Technical Service Bulletin

TSB0204: 2004 King 50 & CM 50 clutch springs (Belleville washer)

April 1, 2004

Figure 1 - Four stack

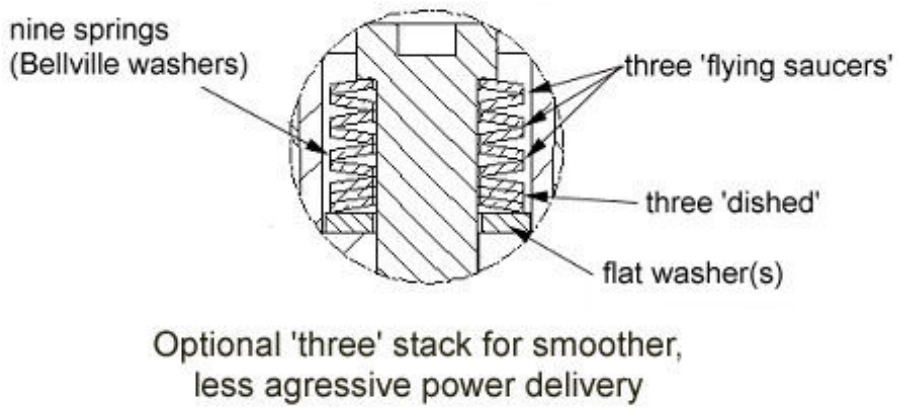
Be sure that the assembled spring stack measures 0.484 ± 0.005 (12.3 ± 0.13 mm). To achieve this you may need to rearrange the spring stack into either the three or four 'flying saucer' stack configuration.
